D/DRC Case

1530 Harden Street

DESIGN/DEVELOPMENT REVIEW COMMISSION
DESIGN REVIEW DISTRICT
HISTORIC AGENDA
EVALUATION SHEET
Case # 6

NATURE OF REQUEST: Request Certificate of Design Approval for addition of dormer-shaped vents on roof

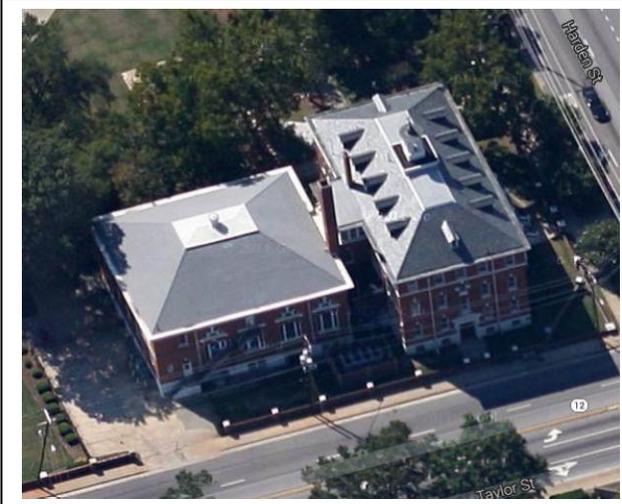
The dormers will not destroy historic material and are compatible to the building's architecture.

The condensing unit will be screened behind a low brick wall which is immediately adjacent to a larger brick wall which one assumes screens other mechanicals. Staff feels comfortable working out details with the applicants.

Although the dormers could be regarded as a conjectural feature, staff finds that since they are required, they are placed in the location most likely to minimize their presence and therefore recommends approval, based upon the other criteria in Section 17-674(d) of the Zoning Ordinance. Staff also recommends approval of the new condensing unit and screen wall with all details deferred to staff.
